ACEC/Maine DOT Bridge Design Subcommittee

MEETING MINUTES

December 10, 2019

Designers Meeting Minutes

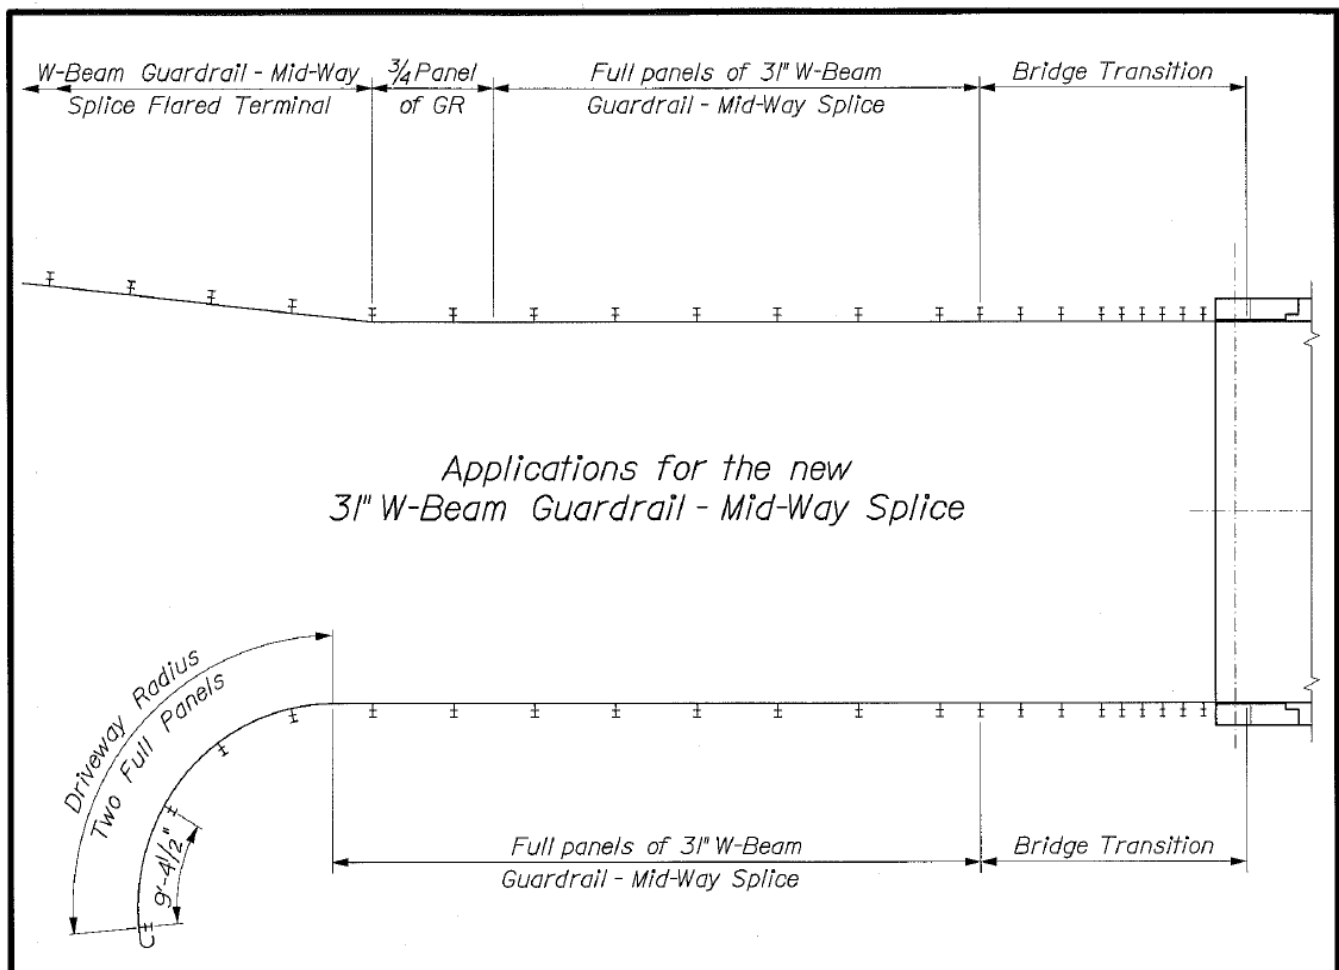
- 1- Because we transitioned to using mid-way splice guardrail, rail length and post layout have to be modified because we still have the bridge transition and terminal ends at a post.
- 2- Currently we have 1-3/4 rail panel at the transition and 2-3/4 rail panels at the rail terminal. The sketch above suggests removing the 3-3/4 panels and have only 1-3/4 panel at the splice flared terminal.

PRECAST CONCRETE TOEWALL DETAIL

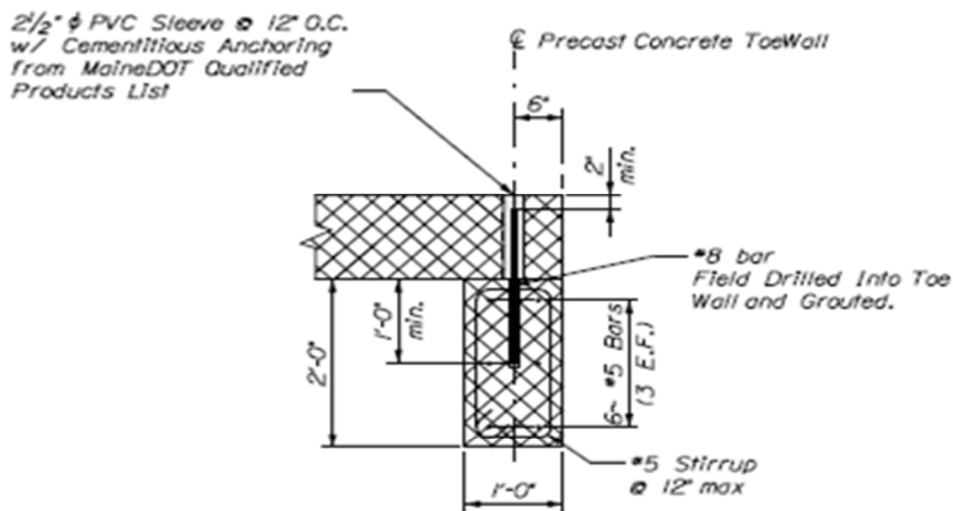
- 1- The detail above show field drilling into toe-wall of a Concrete Box culvert that will be particularly used in Lovell Creek culvert project. The precast bottom slab end is anchored to the toe wall with #8 Rebar. There were questions whether a 2 ½ inch pipe sleeve should be used in the slab, and drilling only in the toe wall, or should we also drill through the slab, thereby eliminating the sleeve. The general opinion was in favor of keeping the sleeve to limit drilling only in the toe wall.

- 2- The next concern was that if we specify the reinforcement, spacing, and embedment, then we assume some level of responsibility should the concrete crack. The general thought that this detail with #8 @ 12 inches provides more reinforcing than previous #8 @ 24, or more spacing, and that we are improving the resistance to cracking by providing more reinforcement.

- 3- The idea of friction fit which is achieved by hammering the anchor rod into a tight hole thereby eliminating grouting requirements was dismissed because of the danger of cracking the concrete under confinement stress from the hammering operation.

- 4- The consensus was that contractors and fabricators could not be trusted to do this work on their own without providing them with a detail such as the one above to execute.

- 5- Most agree that the above detail should become typical for use in other similar projects where precast concrete box culvert with a precast concrete toe wall is used.
